# Mother Color Ltd.

160, Shashongaon, Enayetnagar, Fatullah, Narayangonj, Bangladesh  
(23.627807N, 90.474703E)

12 APRIL 2014

# Observations

# Out-building Vertical column cracks

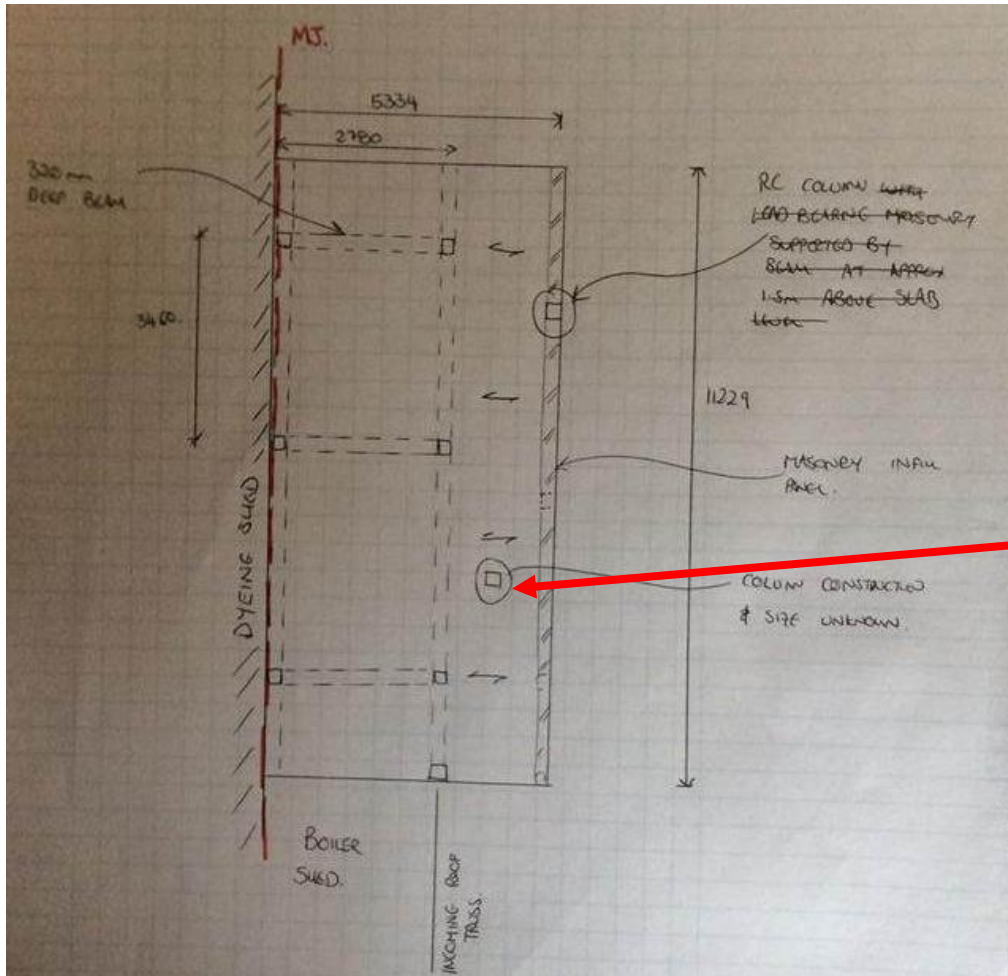
Vertical cracks observed in concrete outbuilding at first floor level. IMMEDIATE ACTION REQUIRED:

Generally the undocumented out-building has two-way spanning slabs supported on downstand beams.

An off-grid column has been constructed between the ground and first floor, connected directly to the slab. The construction of this column could not be confirmed.

An Engineering Assessment should be carried out for this building, to assess the column design and whether the off-grid column will punch through the slab. See photos overleaf.

- Water tank to be drained.
- Floor beams at first floor and roof level to be propped through to ground floor.

## Concrete outbuilding – engineering assessment

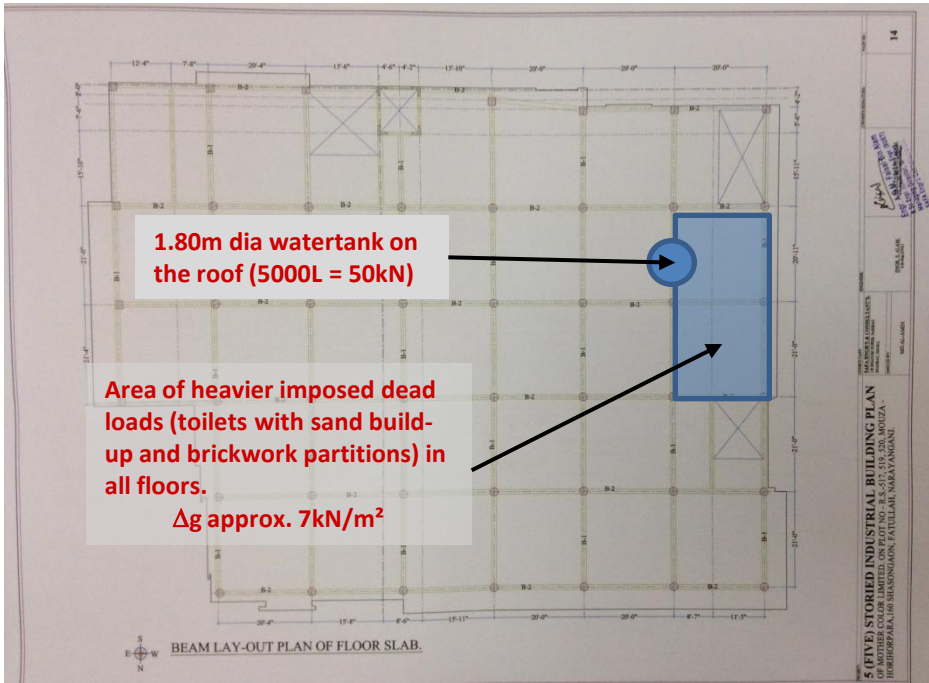
Ground floor column layout, showing first floor downstand beams over.

This column stops at underside of first floor

## Lintels in dyeing shed

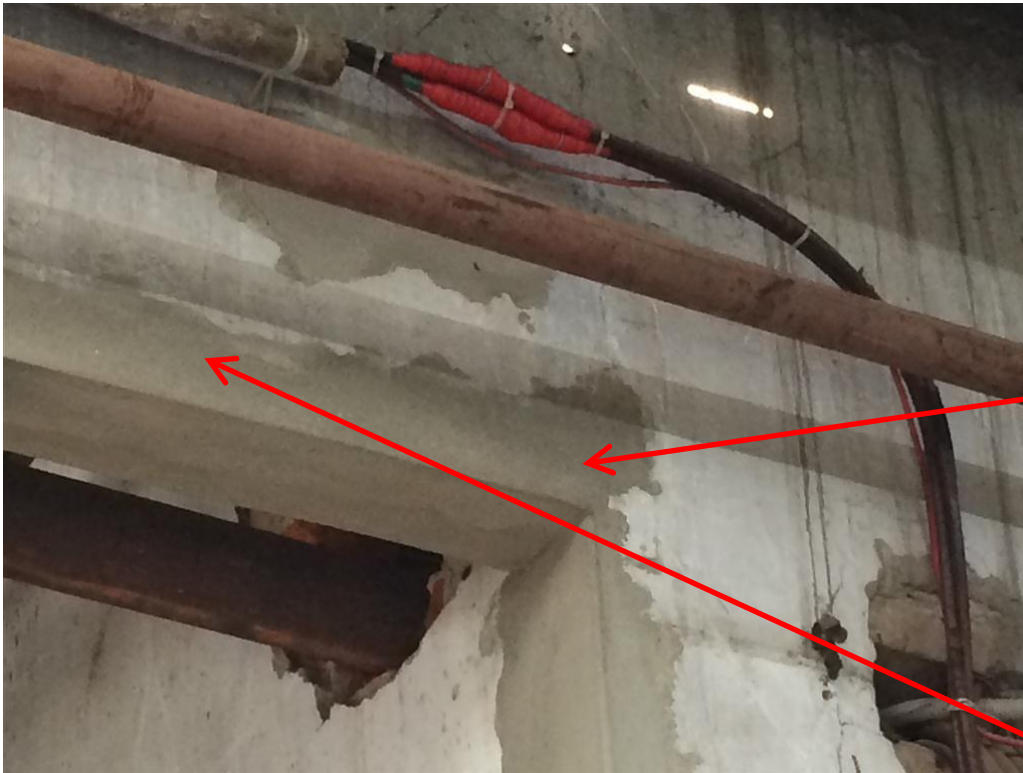
Openings in dyeing sheds appear to have no lintels. Engineer to design suitable lintel to span between masonry walls.

Finishes to be removed to confirm whether lintel has been provided. If not, opening to be propped to prevent bricks falling and injuring building users.

**Dyeing shed – lintels may be inadequate**

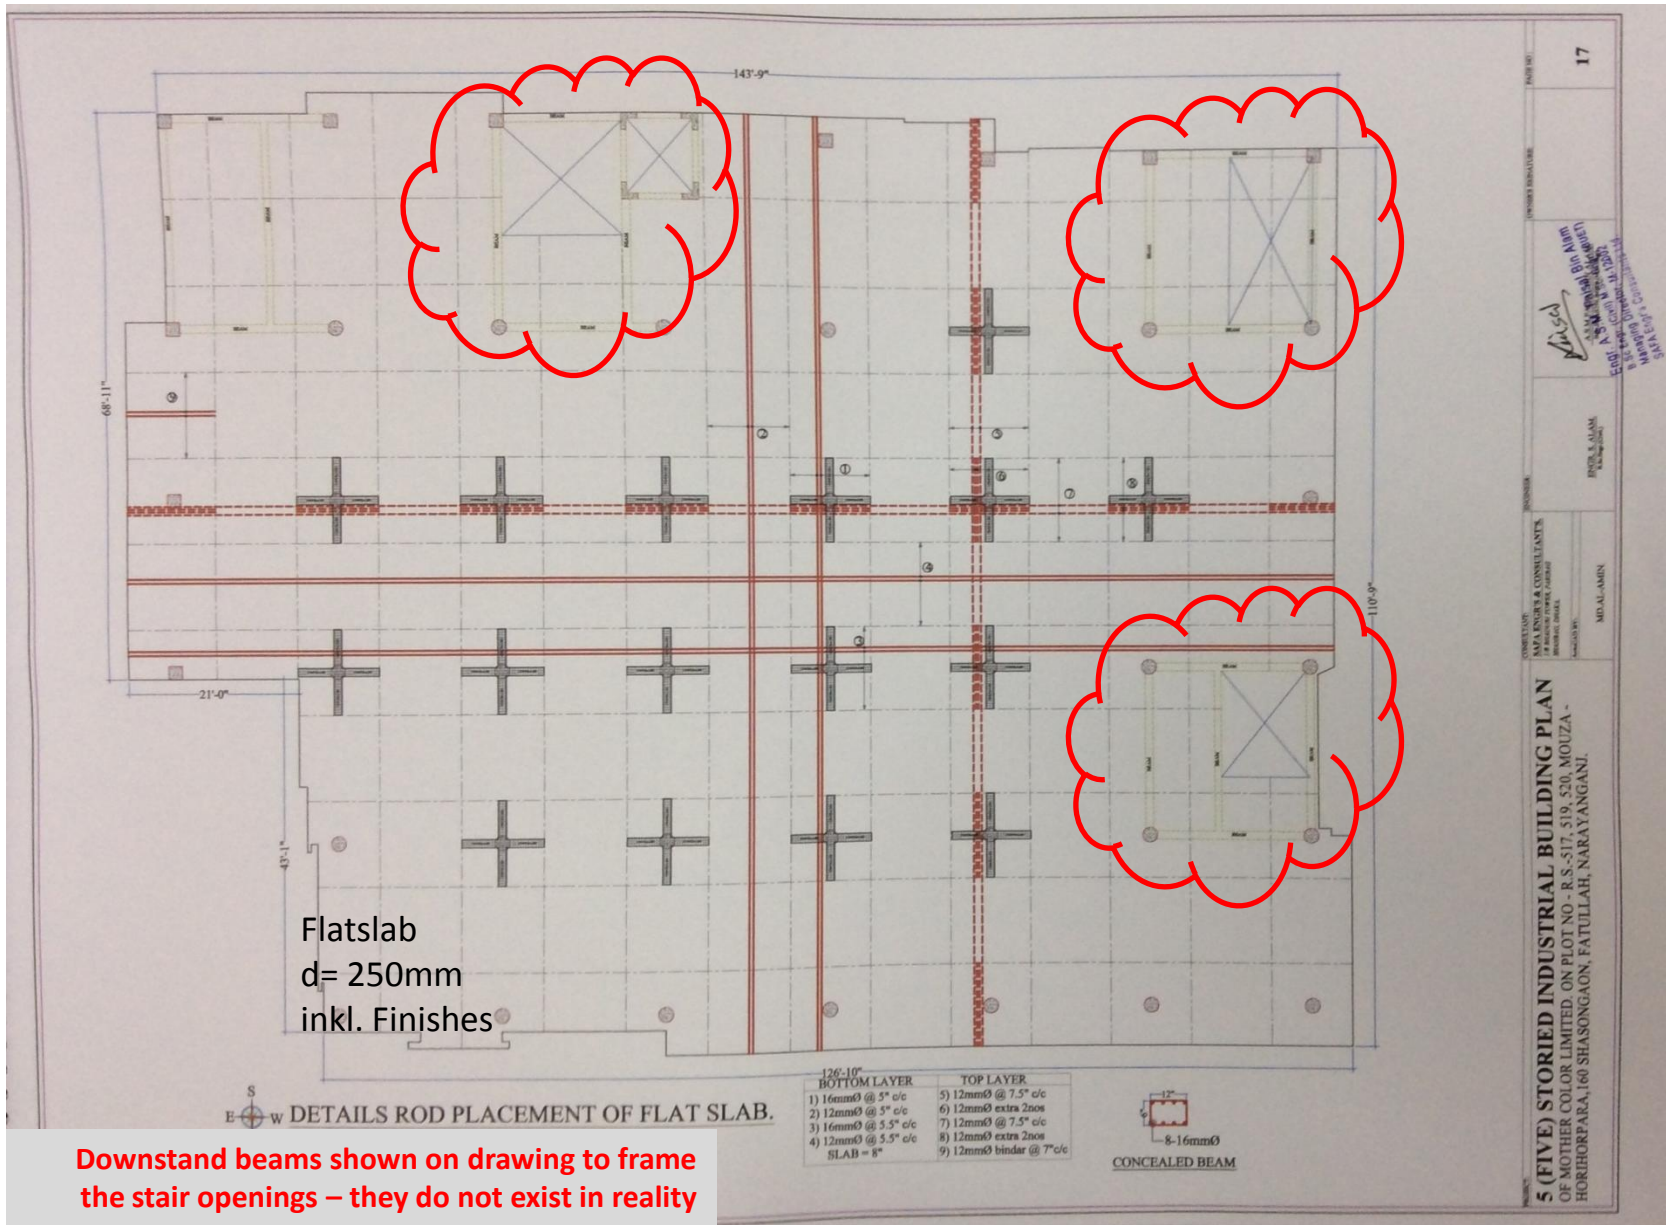
Load-bearing masonry wall

Opening to be propped to prevent bricks falling and injuring building users.

## Dyeing shed - Masonry panel cracks

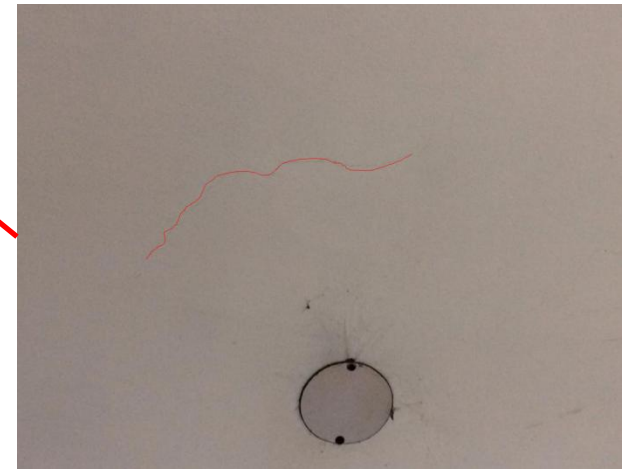
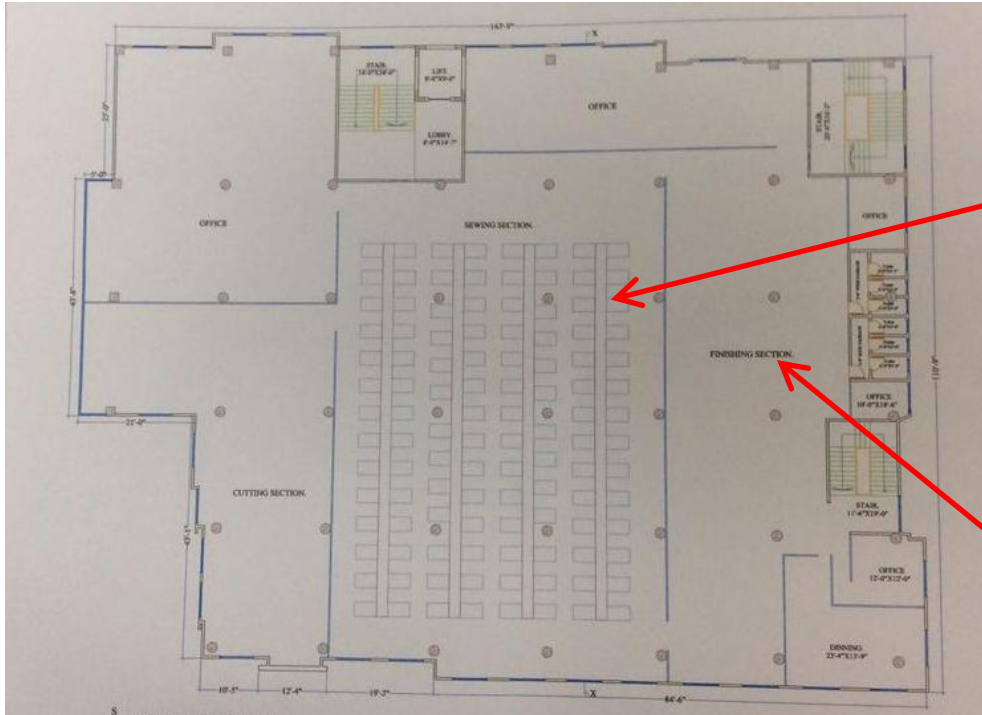
### Cracks in masonry infill panels

Engineer to assess the lateral stability of the masonry panels and whether the stability of shed under lateral loads has been compromised.

Wall should be repaired to prevent on-going maintenance issues.

## No Record of Relevant Structural Documentation

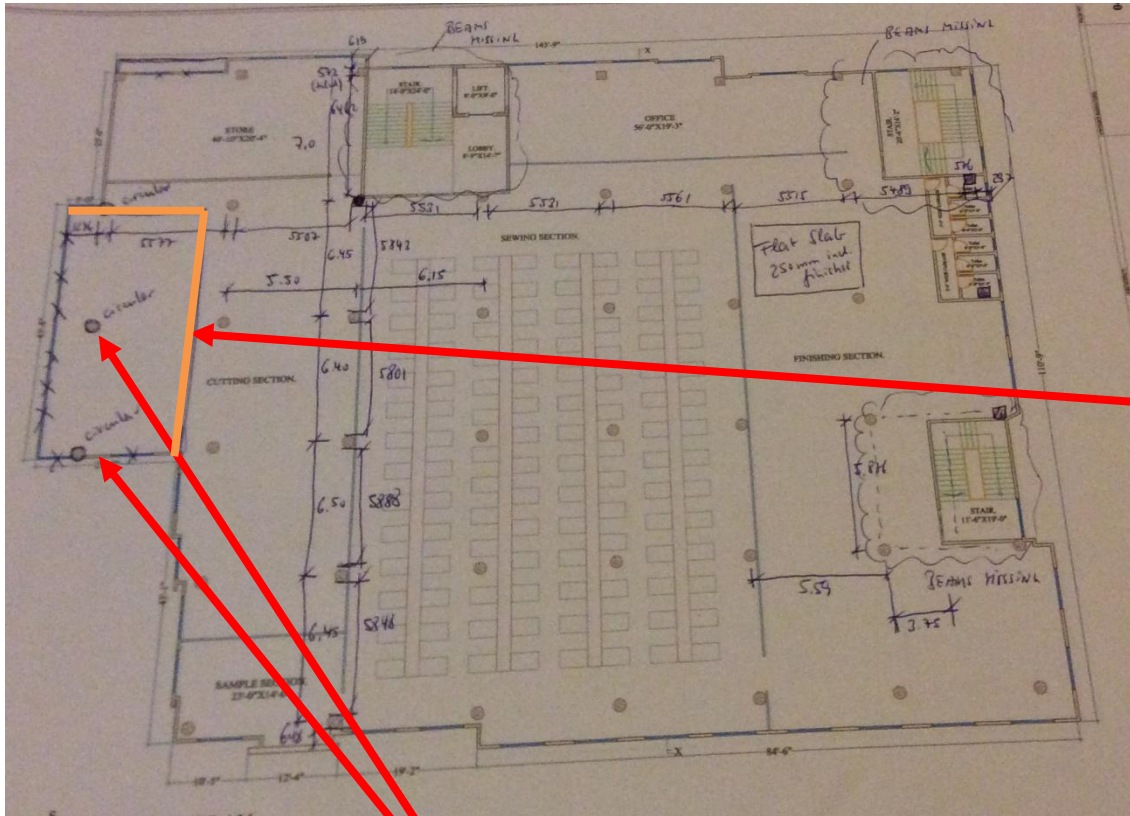
Generally drawings for the main building only were presented.

No permit drawings were shown.

No dates on drawings. Hence it is not clear whether the drawings were produced before or after construction.

- The reinforcement stated on the drawing could not be confirmed by Ferros scanning, which showed significantly less reinforcement in the column.
- The drawings give reinforcement details for columns up to 9<sup>th</sup> floor whilst the building currently has only five levels. **No more floors are to be built pending the outcome of the Detail Engineering assessment.**
- Slab edges on the floors are not shown correctly – particularly on the first floor drawing (area above entrance)
- Column shapes are different in reality to what is shown on the drawing for the edge columns along the short faces of the buildings
- Beams shown on 1<sup>st</sup> and 2<sup>nd</sup> floor layout around the stair cores are missing in reality

## Documentation Issues – Main Building

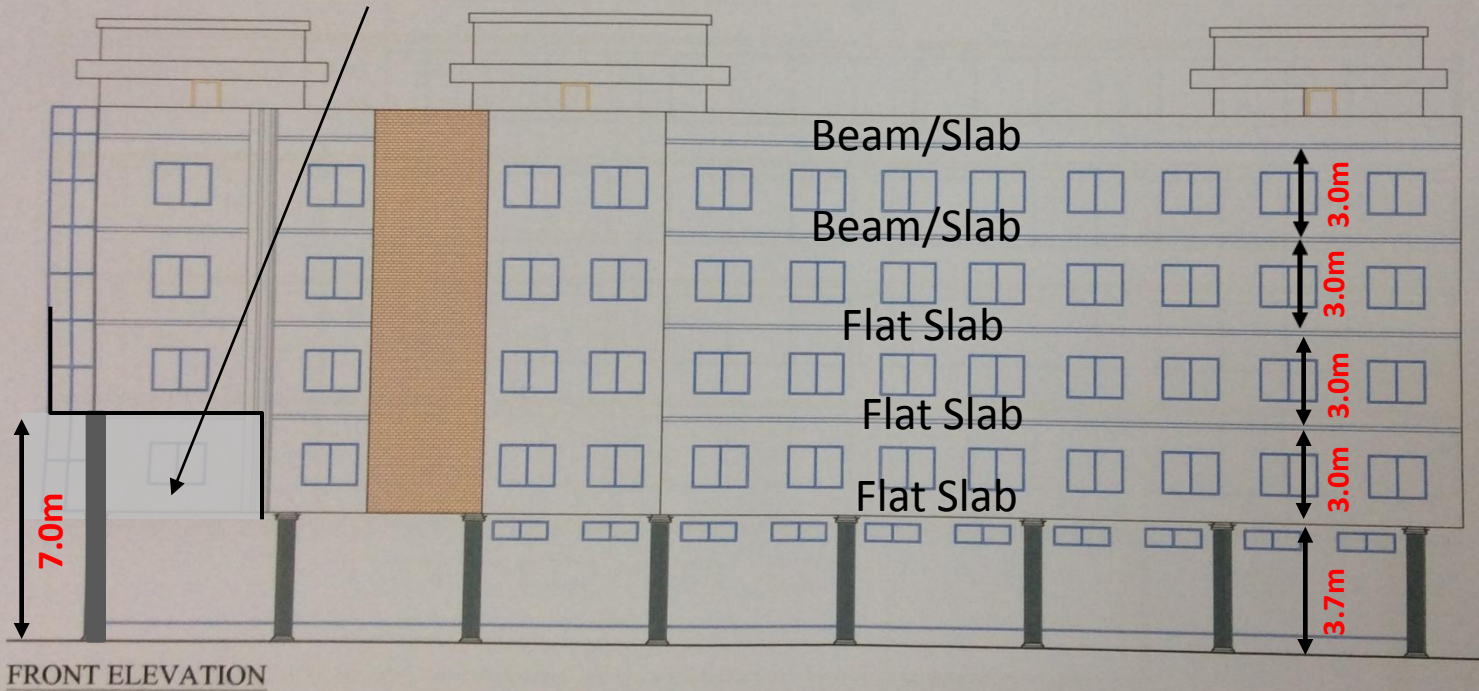
Slab edge at first floor is not as shown on drawing. Columns are unrestrained at first floor. Engineer to confirm that column has sufficient capacity to carry applied loading

Columns are circular in reality, not square

Inconsistencies between the record drawings and as-built frame.  
Engineer to produce as-built drawings that accurately reflect frame construction

Depending on where the section is taken, the edge column is double-height.  
 Section / Elevation and Floor plan for 1st show a different extent of the slab in this area than is actually the case

# Longitudinal Cross Section

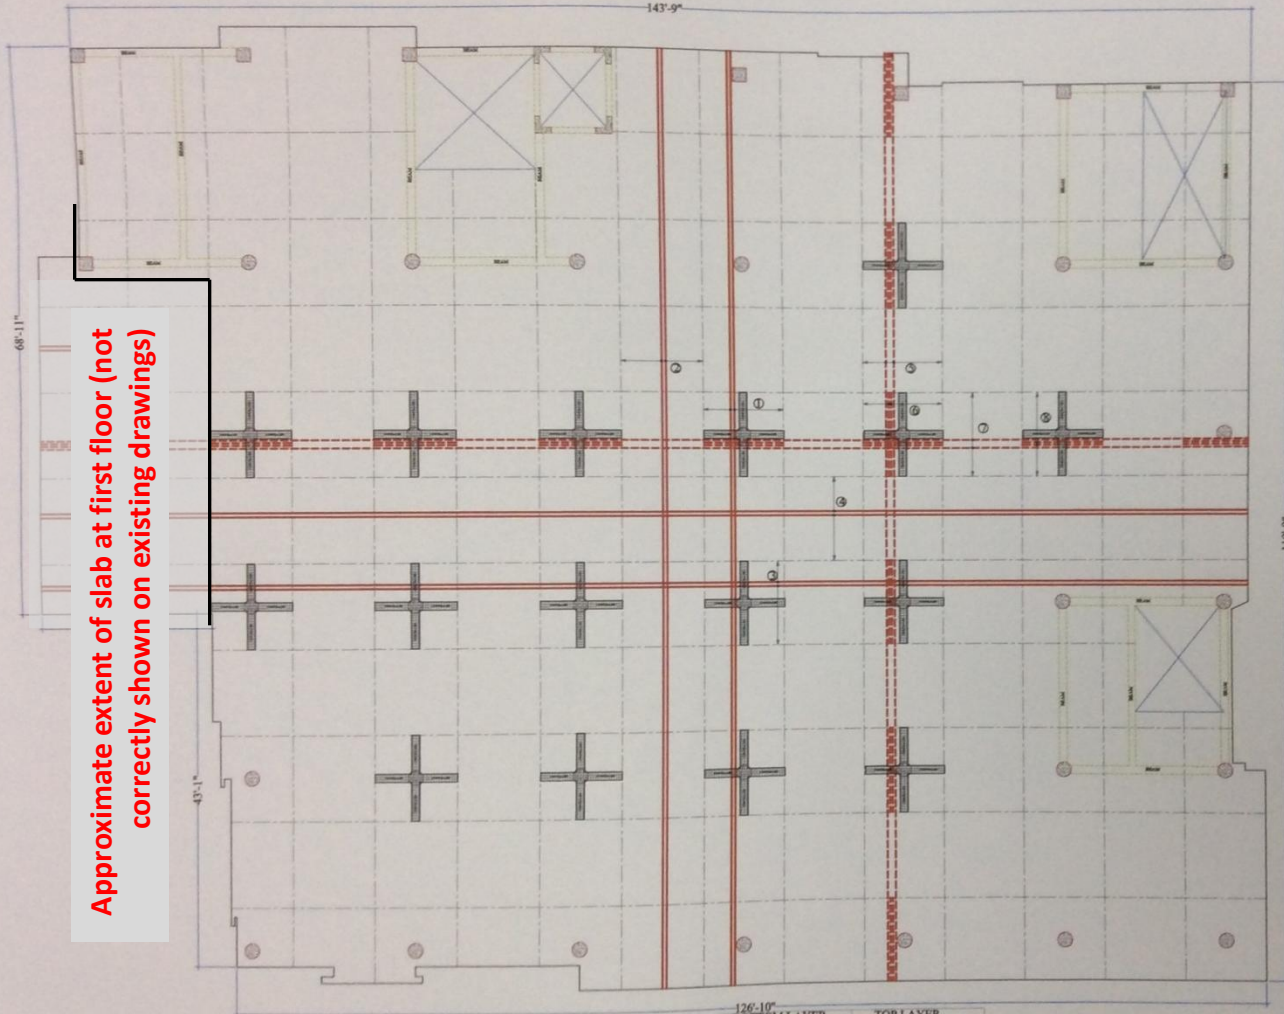
Approximate extent of slab at first floor (not correctly shown on existing drawings)
